## Crow Hill Junction of CEP (240 MW) by Nick MacKinnon

### **Evidence that the proposal for Calderdale Energy Park is unlawful under English common law in respect of *Gunning*.**

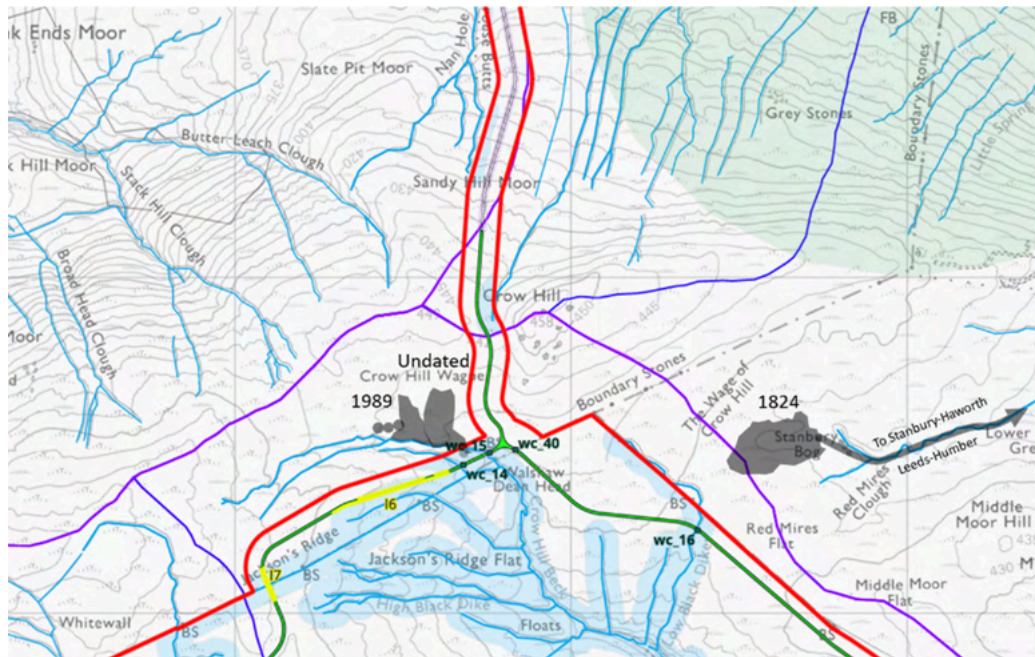
Appendix 10-4 states this September 1824 bog burst complex is “west of the western access route”. It then describes a second bog burst SE of Crow Hill on Stanbury Bog. Had AJM mapped these bog bursts he would have understood that it is the Stanbury Bog event that was on 2 September 1824. AJM has not mastered his own reference Ross 2020 and there is extensive further evidence in the public domain that he did not consult Ross 2020 directly.

#### *Dykes & Warburton 2007 showing 1989 Crow Hill bog slide. Crow Hill on skyline WTRG*

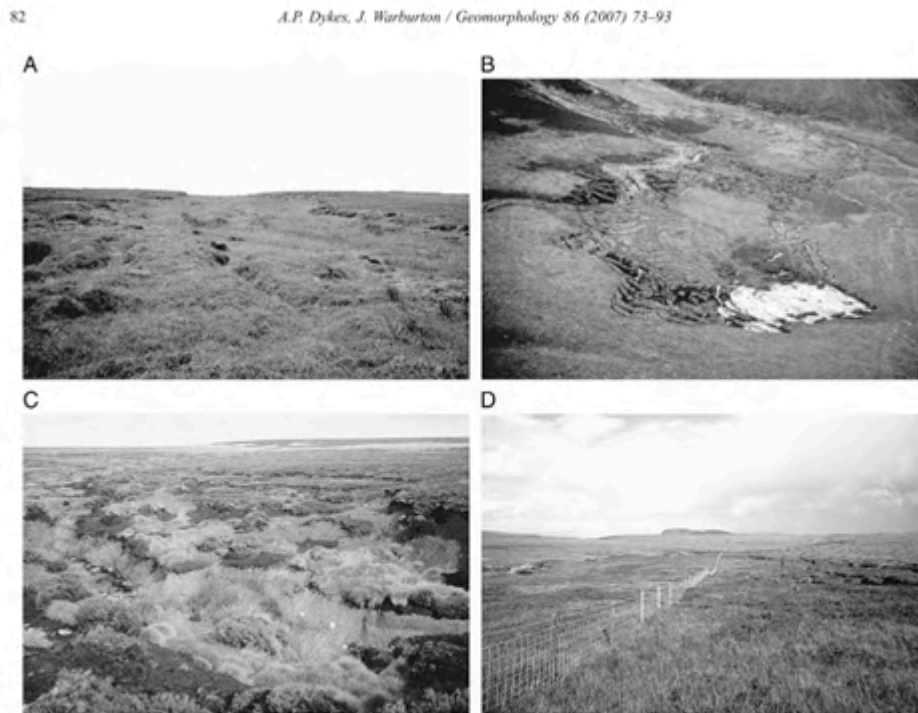
Not only does AJM miss this 1989 bog burst in Ross, 2020, but he also misses it in Dykes & Warburton 2007, a paper of 21 pages to which AJM makes seven dispersed references in Appendix 10-4. The relevant page is shown below.

This 1989 Crow Hill "bog slide" had an estimated volume of 46,000 m<sup>3</sup> and is on low gradient terrain. It falls into the bog burst category (> 10,000 m<sup>3</sup>) of Appendix 10-4 which deals in peat slides and bog bursts as the modelled categories.

*PEIR figure 10-08a*

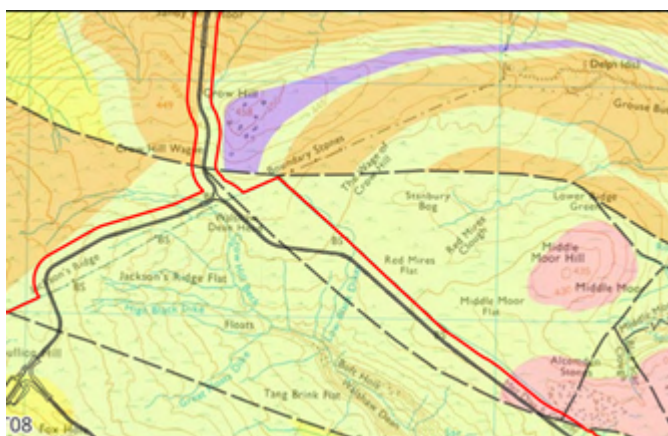
PEIR figure 10-08a shows the proposed infrastructure on a map of the solid geology. Crow Hill is the purple comma at the top. All of the map except Crow Hill shows the typical gritstone bed rock of Lancashire and West Yorkshire. These gritstones are porous. The remarkable exception is Crow Hill, whose bed rock is Keighley Blue, a rock named after the nearest large town to Crow Hill, and found nowhere else. Keighley Blue is an exceptionally well cemented impermeable siltstone, shaly in appearance. Its strength and low porosity made it valuable as a local roadstone, in contrast to the weak and porous aggregates made from the almost universal gritstones.

The explanation for the uniqueness in mainland UK of Crow Hill as a multiple bog burst/slide host lies in this unique geology shown in detail on the map below.

*Detail of PEIR 10-08a map showing Crow Hill hydrological discontinuity*

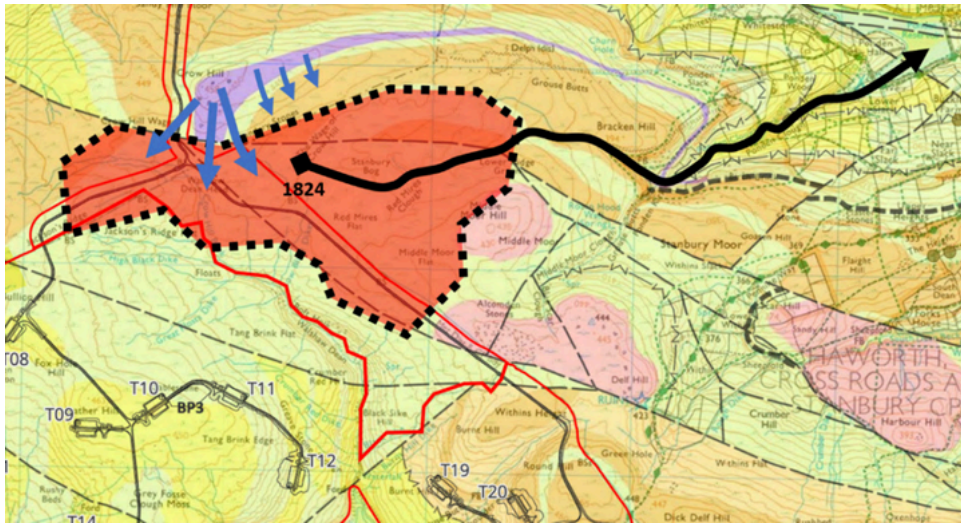
The map above shows the unique impermeable Keighley Blue of Crow Hill. The CEP track from the north is the sole proposed delivery route for the turbine components from the M65 at Colne. The track must also carry the whole 616,000 tonnes of noncalcareous hardstone aggregate that is required to build the tracks. Two other

floating tracks converge at the Crow Hill junction. Both tracks cross the Crow Hill bog burst source area, which has had up to eight bog bursts between 1824 and 1989.

*[Unanticipated C682 aggregate track 'bypass' and Crow Hill requirement: WTRG on PEIR base]*

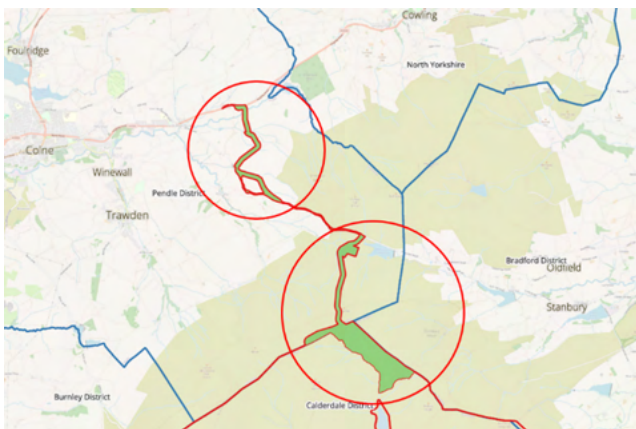
The C682 Lancashire Moor Rd requires a bypass because the bridge at Laneshaw Bridge is not suitable and School Lane beyond road is too sinuous and narrow. The expense and destructiveness of this bypass are likely to exceed that of the works needed via Halifax. Land has to be purchased from a range of landowners. The complexities on Crow Hill are indefinite in difficulty because of peat slide risk on the steep ascent and the known bog burst hazard on Crow Hill Wague and the Wage of Crow Hill. The liabilities are indefinite, extending beyond the site lifetime. The land on the Lancashire side of Crow Hill (LA518044) has to be purchased from the Walshaw Moor Estate as Algihaz have no option on it. Algihaz have had an option on all the land in the extended red line on the Yorkshire side (YY196927 and WYK72194 which includes Crow Hill Wague and Wage) since 11 November 2021. (Larger circle) At due diligence, Algihaz had no expectation of building heavy infrastructure on the uniquely unstable Crow Hill, nor of expensive and destructive track building north of the C682.

No reasons have been published for the rejection of Option A via Halifax in preference to Option B via Colne and the indefinite hazards of Crow Hill described here.
